## **Hearings Panel**

### **Colombo Street Cycle Route Connection**

### **AGENDA**

- 1.1 The purpose of this report is to report the outcomes of the consultation phase for the preferred scheme design for the Colombo Street Cycle Connection project. This report has been written by staff to provide the Hearings Panel with the background and recommendations for this project to proceed.
- 1.2 The decisions in this report are of medium significance in relation to the Christchurch City Council's Significance and Engagement Policy. The level of significance was determined due to the high level of interest Christchurch residents have in relation to cycle lanes and parking in the central city.

Figure 1 - Cross path turning conflict between bike and motor vehicle.

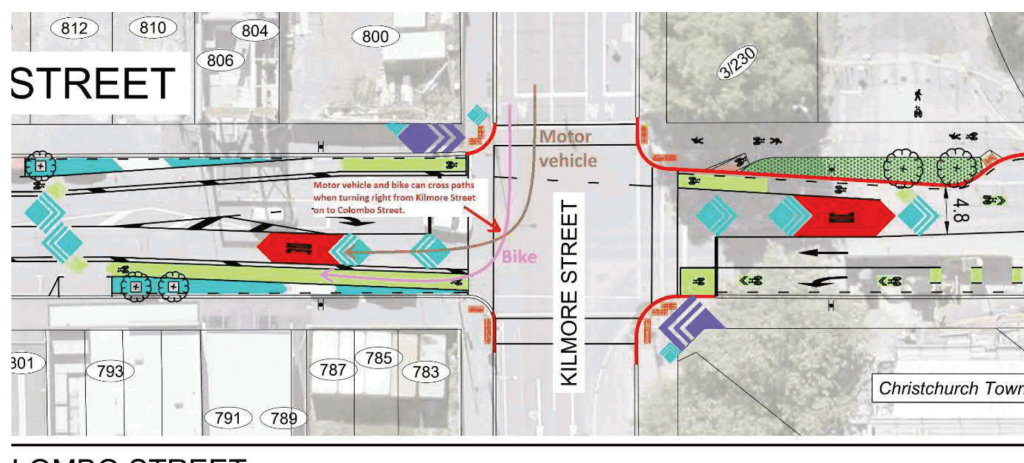
I have a small comment on the Kilmore Street and Colombo Street intersection. I understand it is only loosely related to this work, so I understand if it is considered out of scope. A cross path conflict can occur if both a person biking and a person driving turns right on to Colombo Street from Kilmore Street. See the figure below:

Submitter #35494

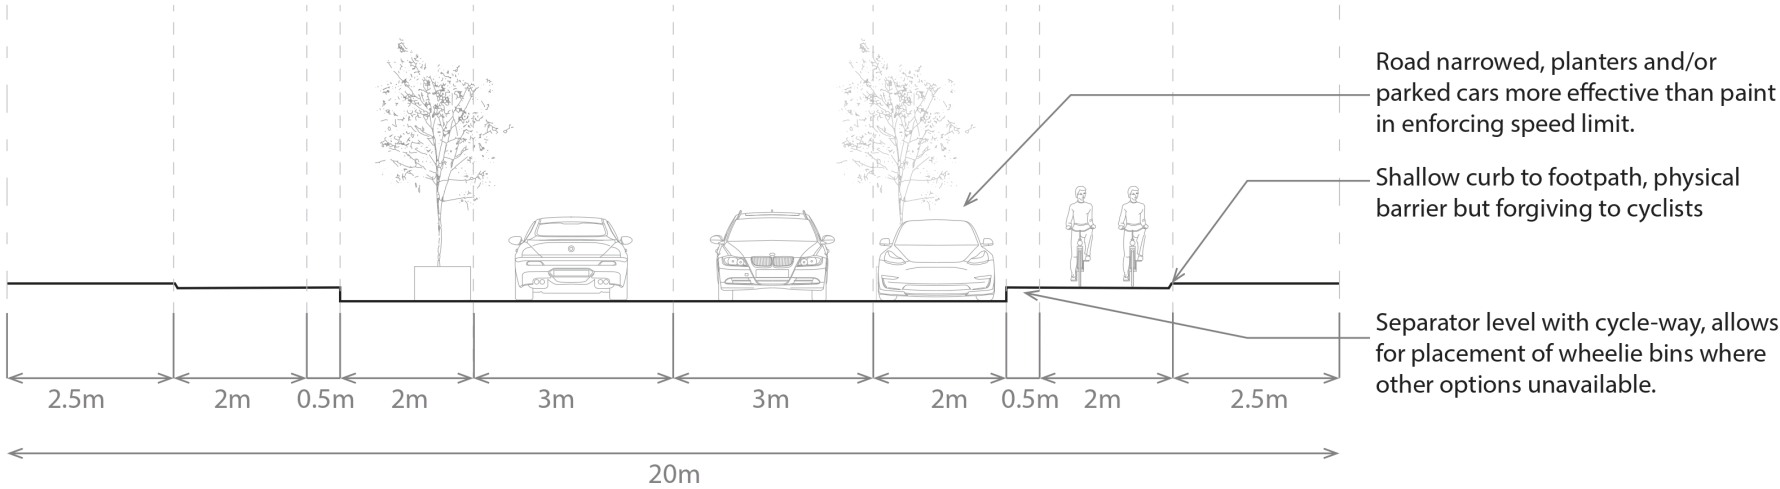
- Cycle crossings set back by 5m from intersection, protected by re-aligned curb. Tighter turn radius forces driver to slow, when they cross cycle route driver is perpendicular to cyclist, allowing both to make eye-contact with minimal effort. 5m = rough length of car. If wider turning circle is required for heavy vehicles turning lane can be set-back further.
